Subject: Interstate 4 from West of State Road 528 (Beachline) to West of State Road 435 (Kirkman Road) Value Engineering Study Recommendation Dispositions

FM: 242484-7

Value Engineering Study **Draft** Report

SINGLE POINT URBAN INTERCHANGE (RECOMMENDED)

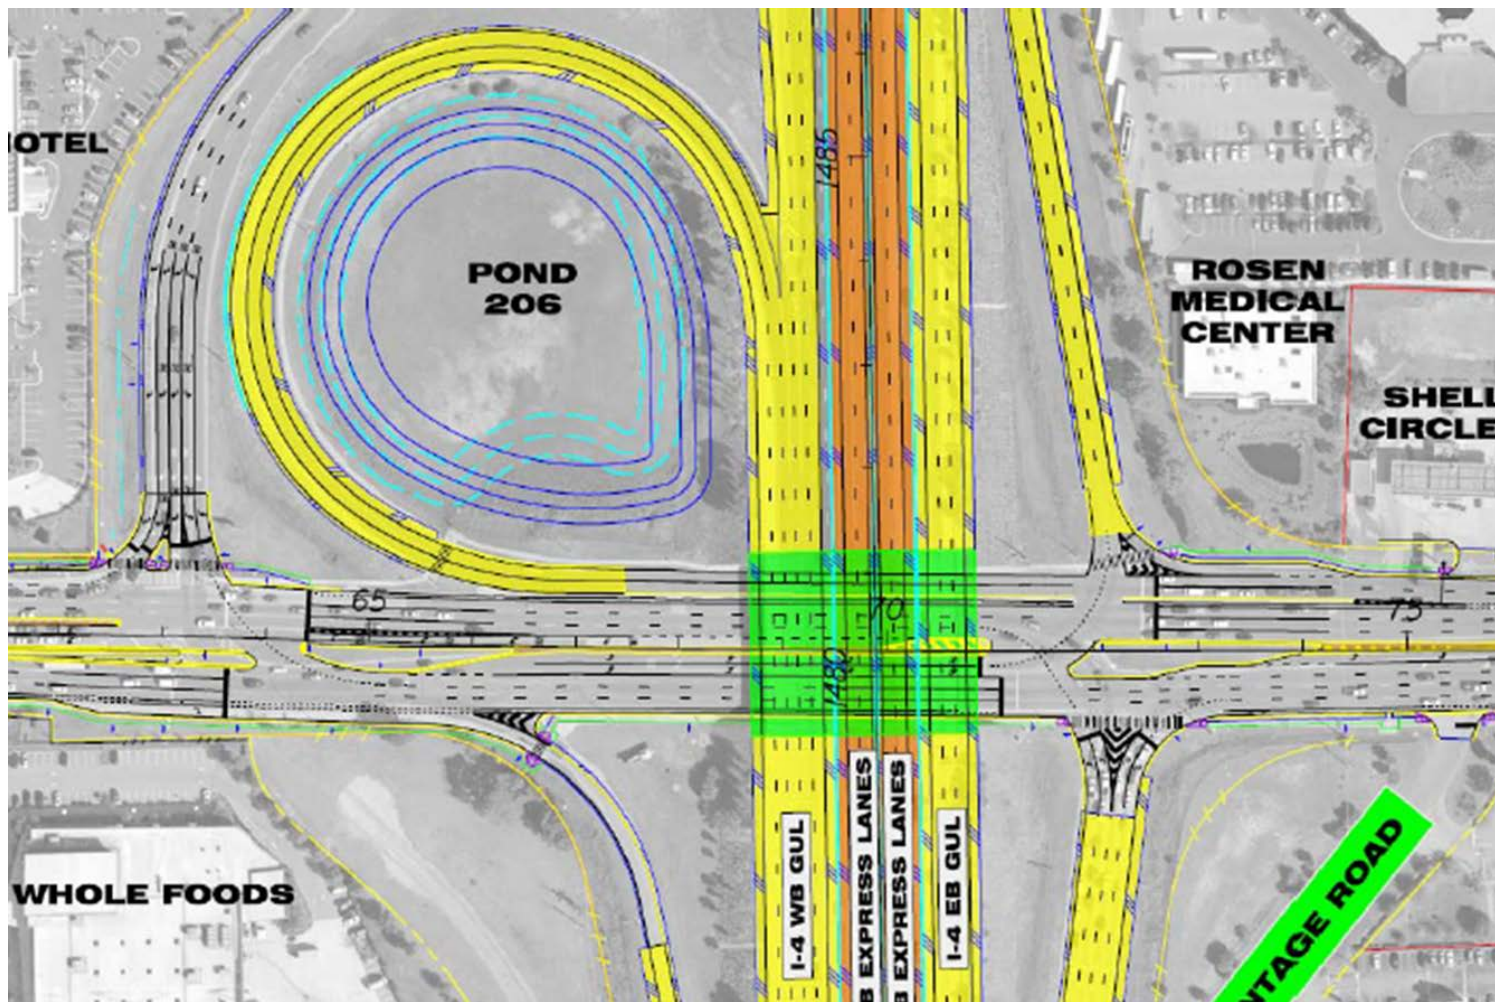
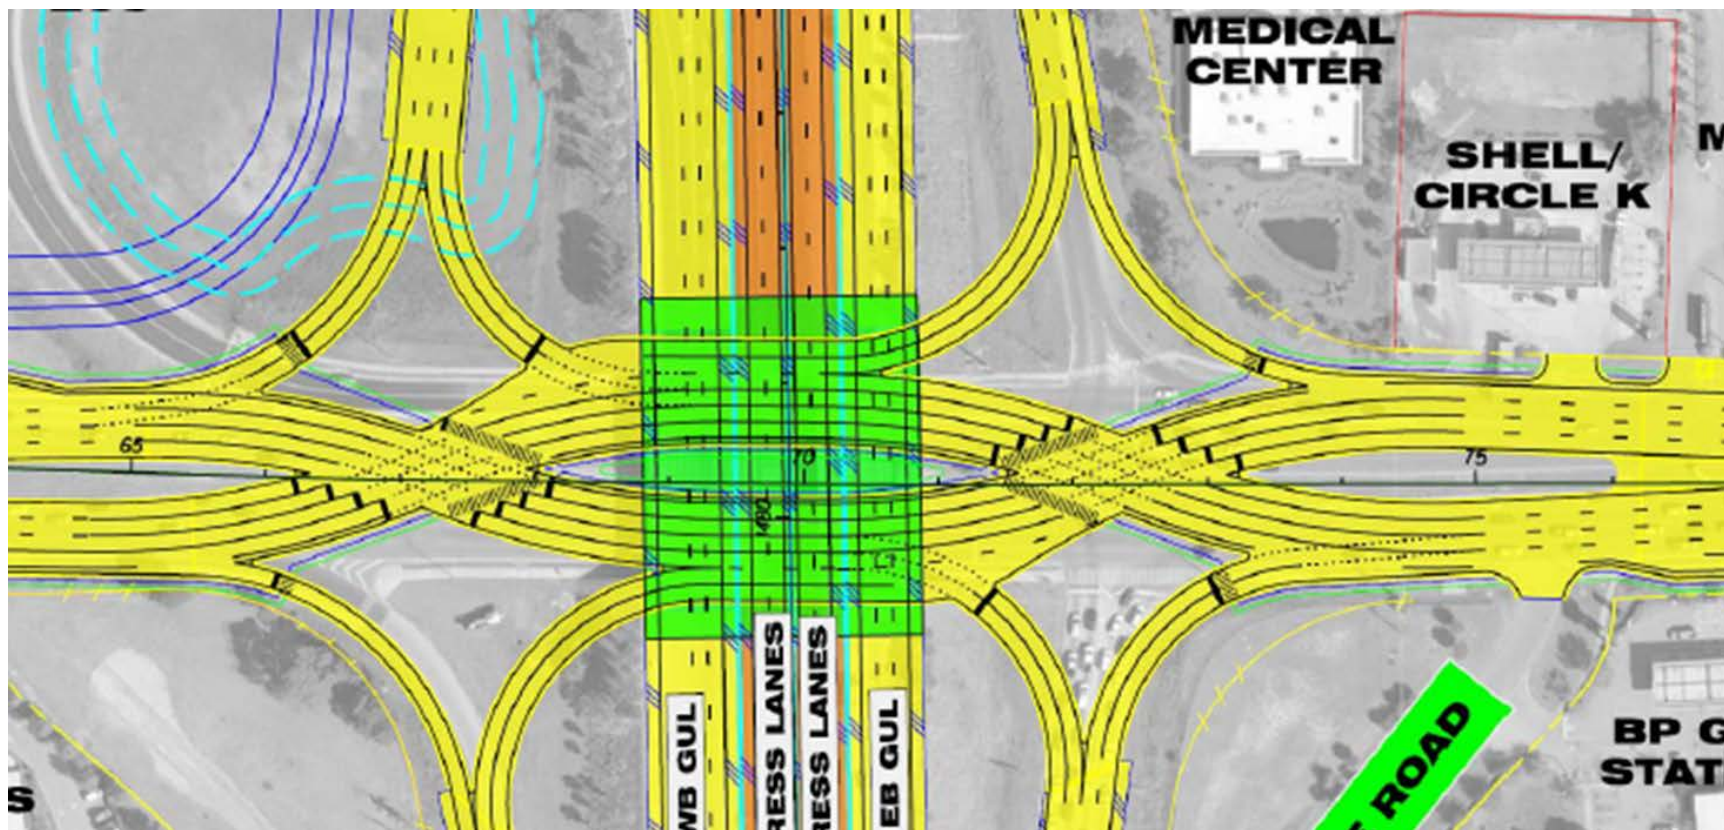
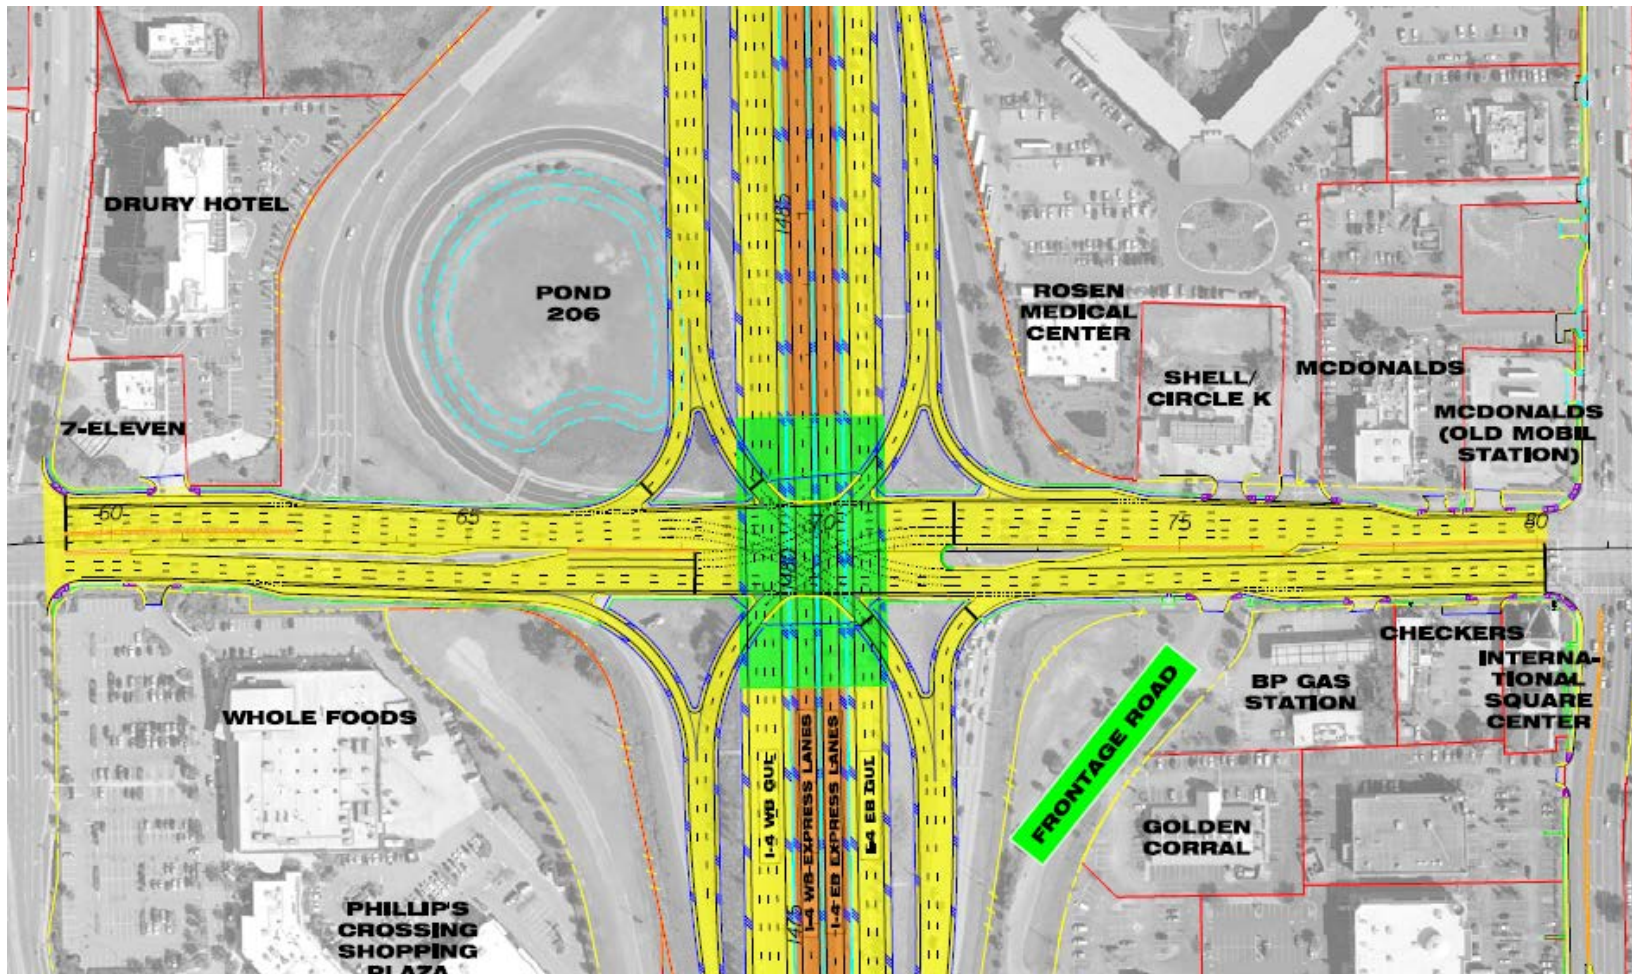
RECOMMENDATION No. 8: Consider Single-Point Urban Interchange at SR 482 (Sand Lake Road)

The PD&E Documents show two alternatives. The first alternative is a combination diamond/partial clover-leaf interchange. The second alternative is a diverging-diamond interchange (DDI).

A third alternative, consisting of a single-point urban interchange, should be considered. The VE team recommends constructing a single-point urban interchange (SPUI). This concept will reduce the number of signalized ramp intersections from two to one and will improve operations of the system and is more user friendly for pedestrians and bikes through the corridor.

Accepted. A single point interchange was considered at Sand Lake Road and from an operational standpoint, the Diverging Diamond interchange outperformed the Single Point.

RECOMMENDATION No. 10: Eliminate the ramps to and from Central Florida Parkway

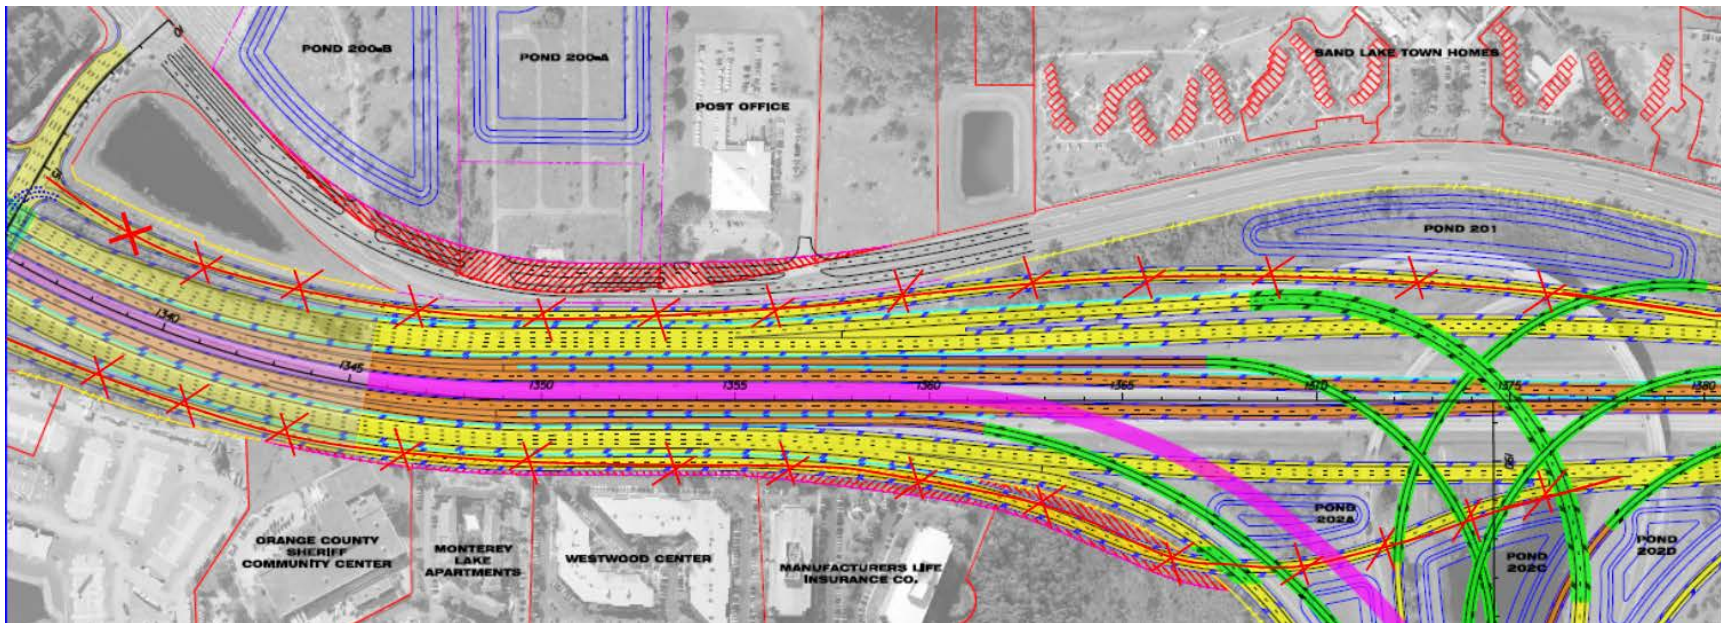
RECOMMENDATION No. 10: Eliminate the ramps to and from Central Florida Parkway

The PD&E Documents show a southbound off and northbound on ramp connecting the I-4 general use lanes to Central Florida Parkway.

Not accepted. Additional research revealed previous coordination with FHWA. The memos retrieved require that ramps to and from the east be added to the Central Florida Parkway interchange.

ALTERNATIVE 2 (RECOMMENDED)

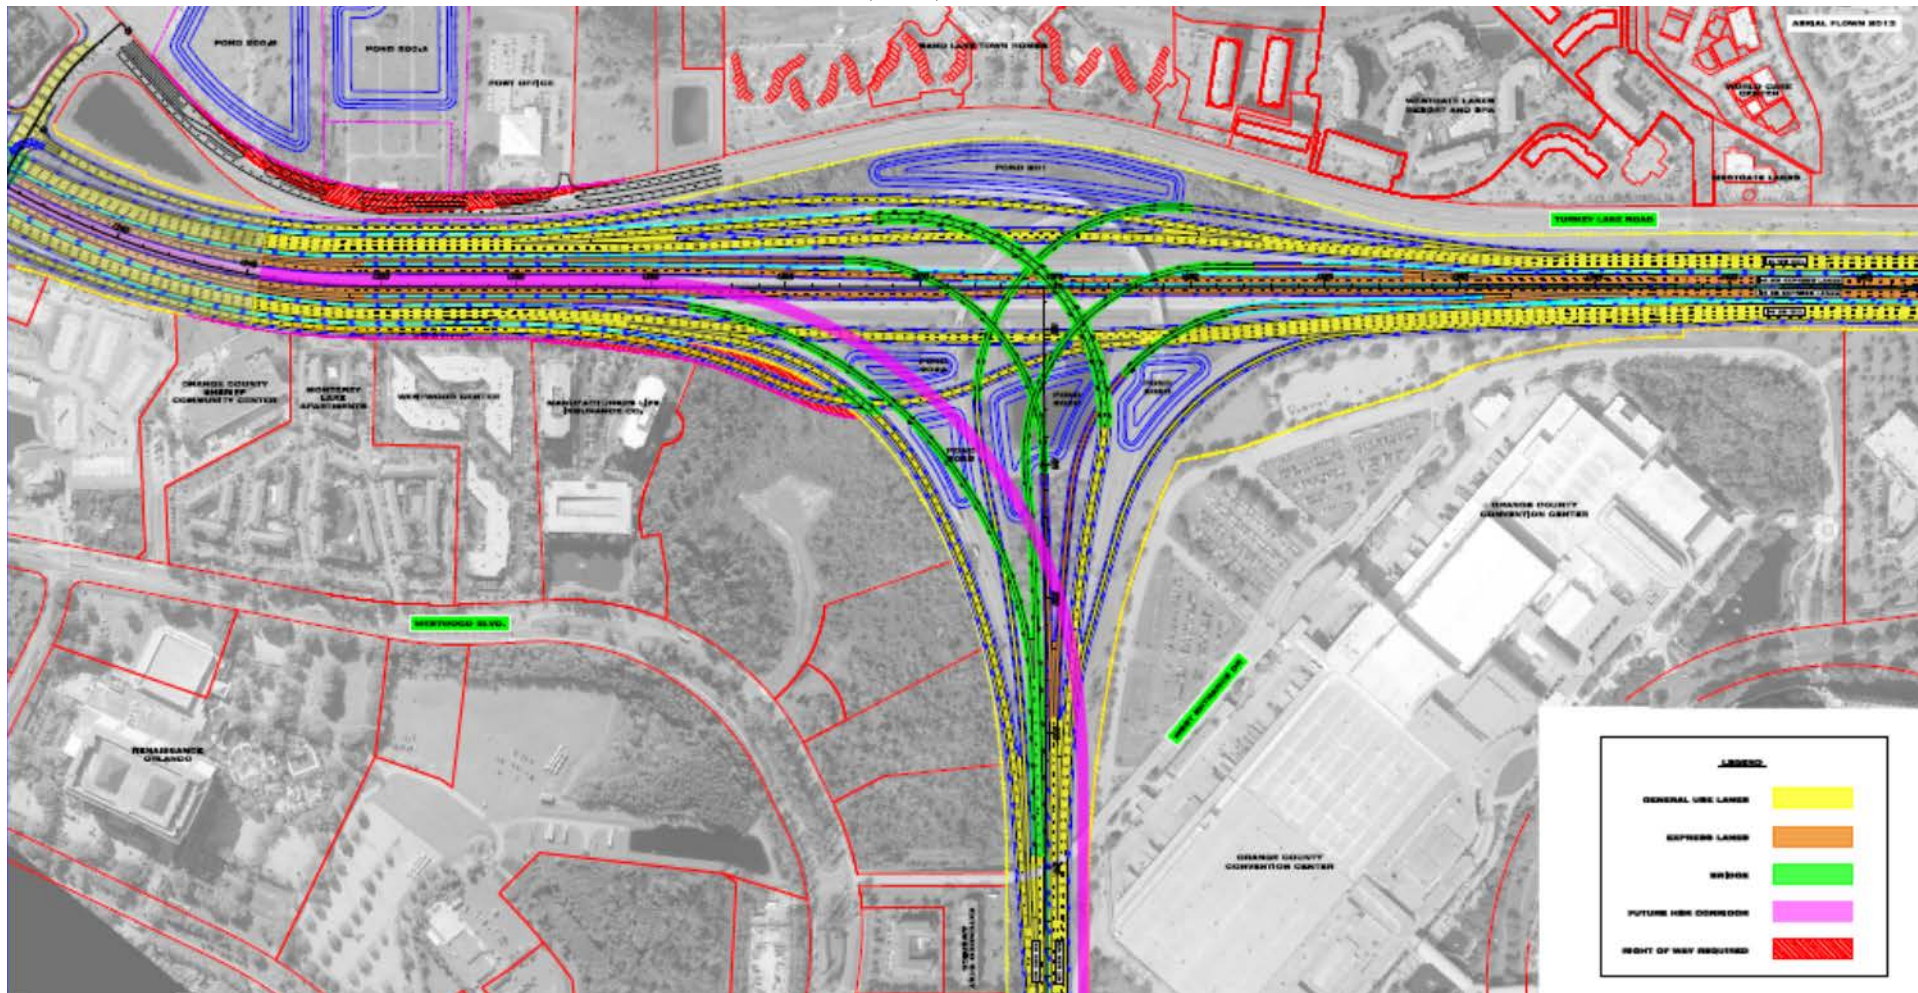
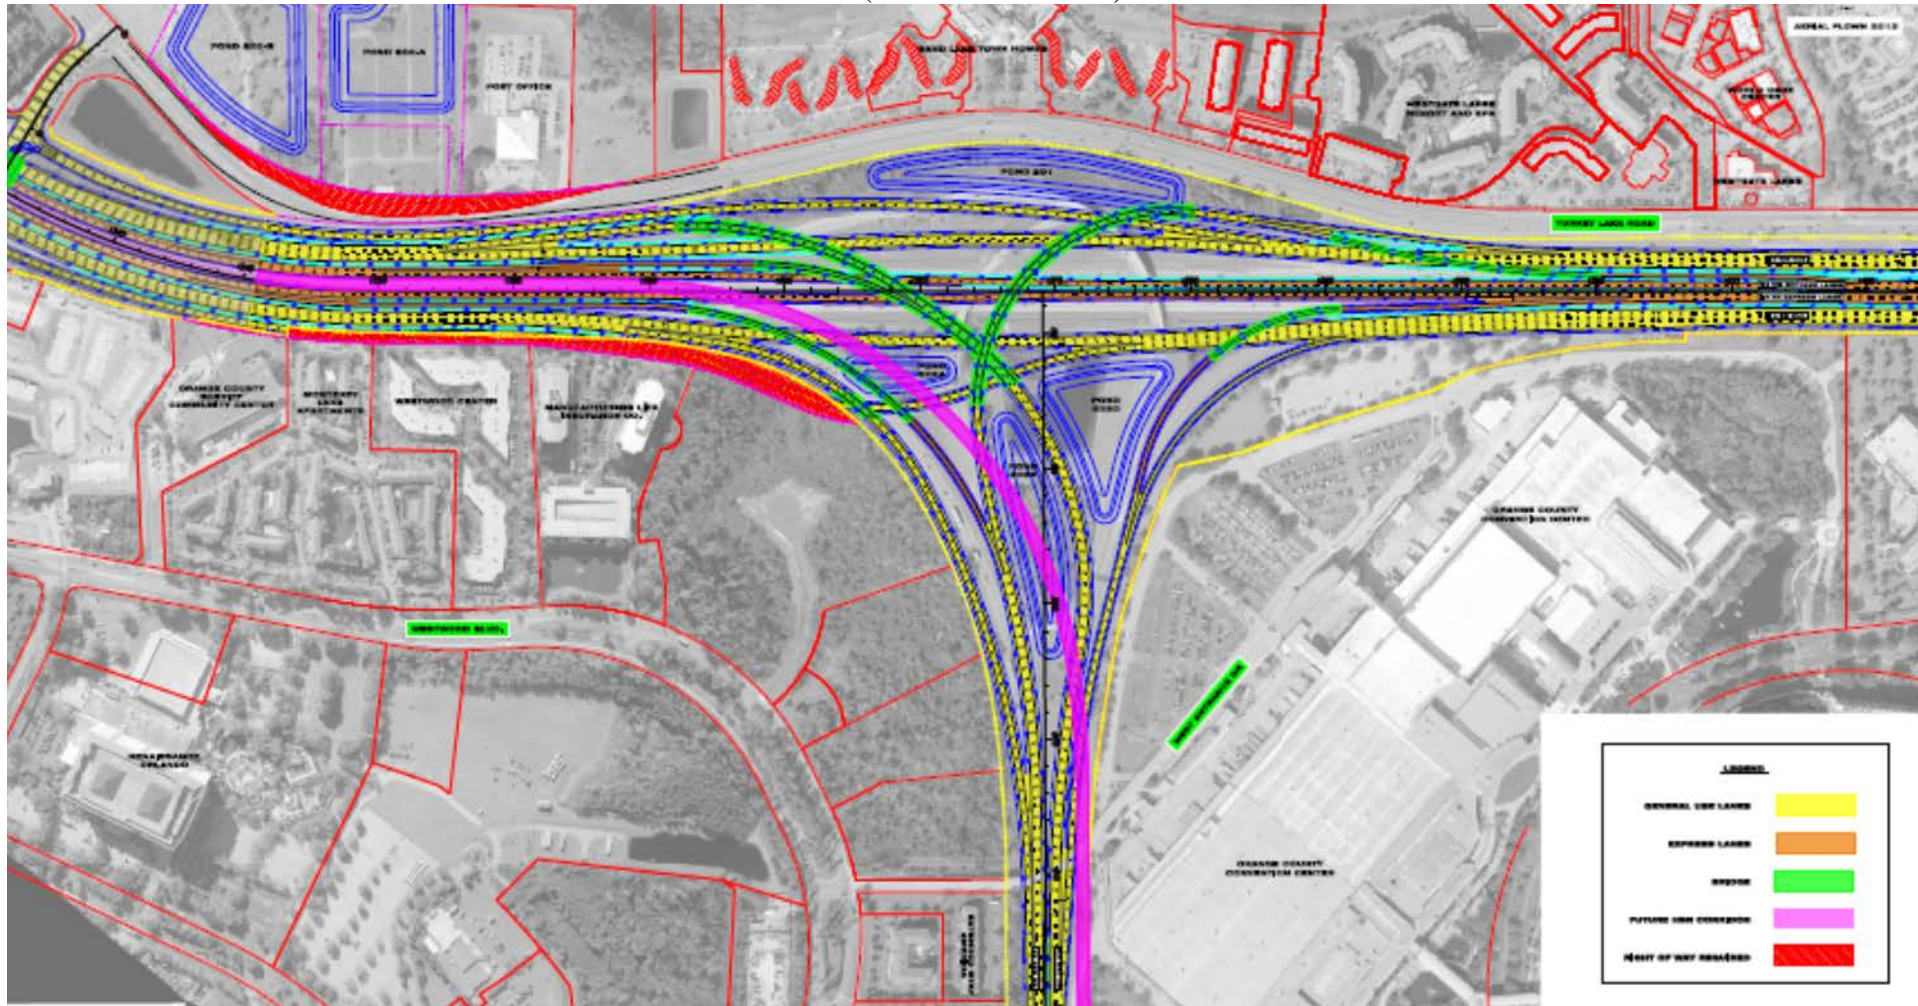
RECOMMENDATION No. 11: Combine ramps similar to SR 528 Alternate 2

Alternative 1 is the baseline Alternative used by the VE team. The two mainline typical sections show that the majority of the roadway will be contained within the existing right of way (300 ft. minimum) with exception of the pond sites. The total length of bridges is 7,397 ft. with Construction Cost of **\$169,335,848**. Wetland impact is 4.27 acres {data taken from PER dated January 30, 2014 – Table 20}. Alternative 1 proposes several separate connector ramps with different elevations as follows:

Accepted. Ramps will be combined similar to the SR 528 Alternate 2.
